Consultant	Wahib Medanat Consultant Engineer	Rep No.	13-17102021
Contractor	Derar Saraireh & Sons for Engineering & Contracting	Tender No.	(11/2019/USAID/SKEP/3/S) Schools for a Knowledge Economy Project (SKEP) - Phase (3) Package (1, 2)
Site Name	Khadija Bint Khwailed Basic Mixed School- Shouna Janoubia	Day/ Date	Sun. 17/10/2021
Duration of Project	450 Calendar Days	Total Project Budget	9,789,417.840 JD

# SKEP III Home Office Support Site Visit Report

(Figure: 09)

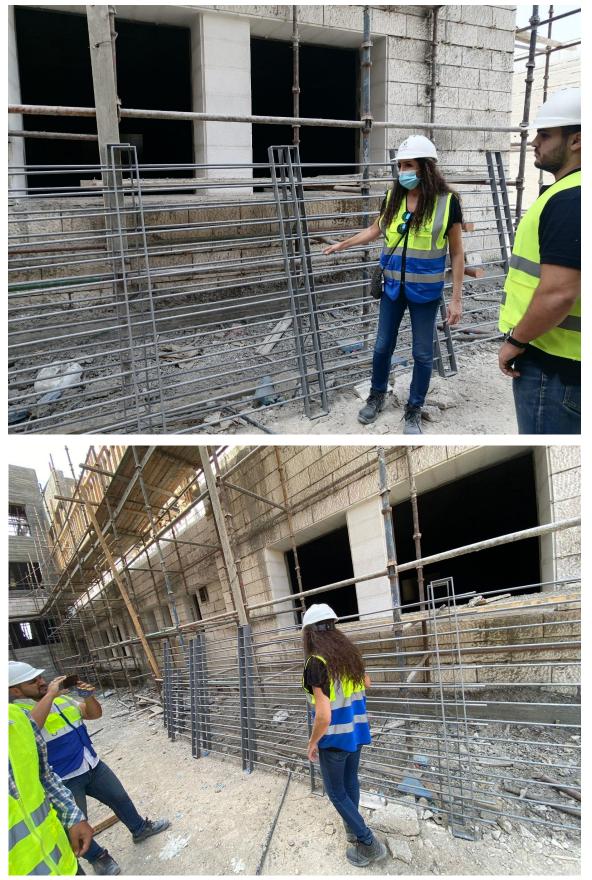
The Contractor imported the steel grill protection and the supervision team inspected before installation (*Figures: 09 &* 10)

(Figure: 11)

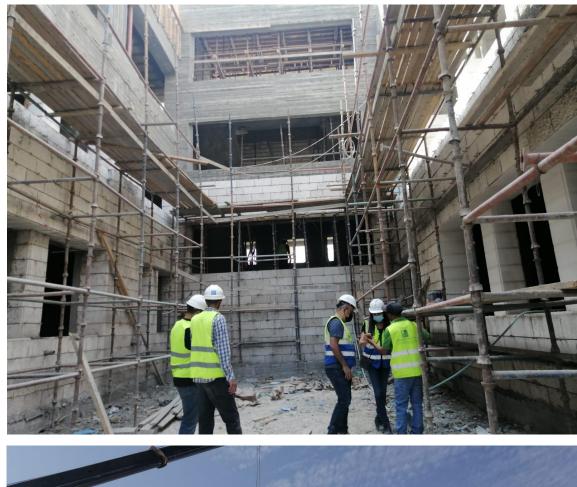
General inspection was conducted on the stone building for facades

(Figure: 17)

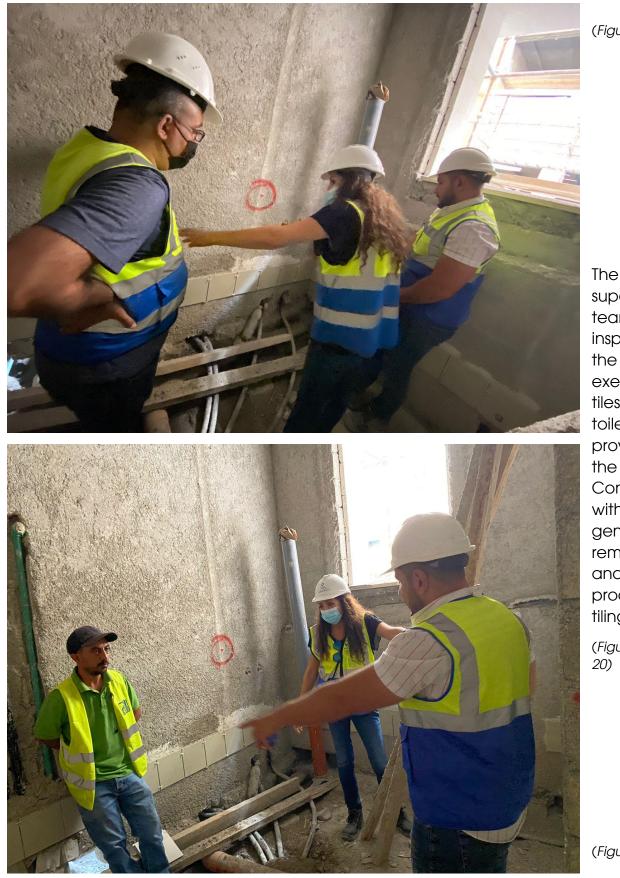
The installation of mechanical cabinets in the toilet area was inspected to insure the compatibility with tiling and proper cut-off tile pieces

The Contractor was requested to rectify the location of cabinets slightly to avoid small cut-off tile pieces
